SUBJECT: Approval of Moon, Stevens, and Rugg Brook TMDLs

EPA NEW ENGLAND'S TMDL REVIEW

TMDLs: Moon, Stevens and Rugg Brooks, Vermont

DATE: February 19th, 2009

Figure 5. High flow portion of the flow duration curves for Moon Brook and attainment stream.

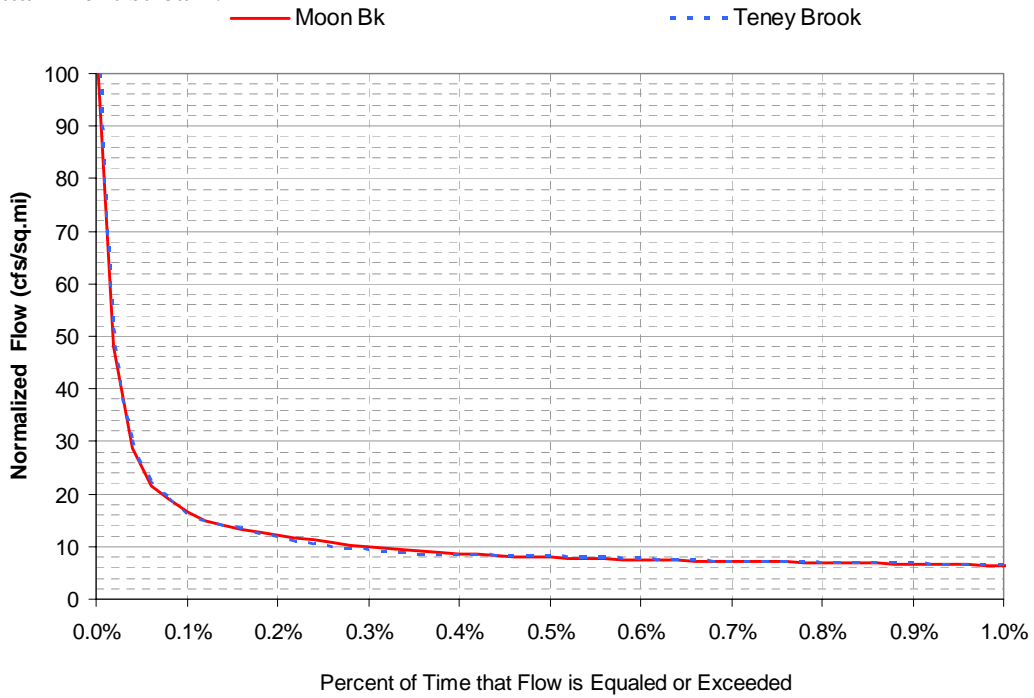
4. Page 14. The coincident of the graphs in Figure 5 does not seem to support a significant expenditure of resources to reduce stormwater related flows in Moon Brook. [Rutland]

Response: As noted in the TMDL, the high flow reduction target from current modeled conditions is 12%. Across the spectrum of the stormwater impaired streams for which TMDLs have been developed, this percent flow reduction is relatively modest. However, at this time watershed-specific implementation planning and cost estimates have not been developed to estimate the resources required to achieve this target.
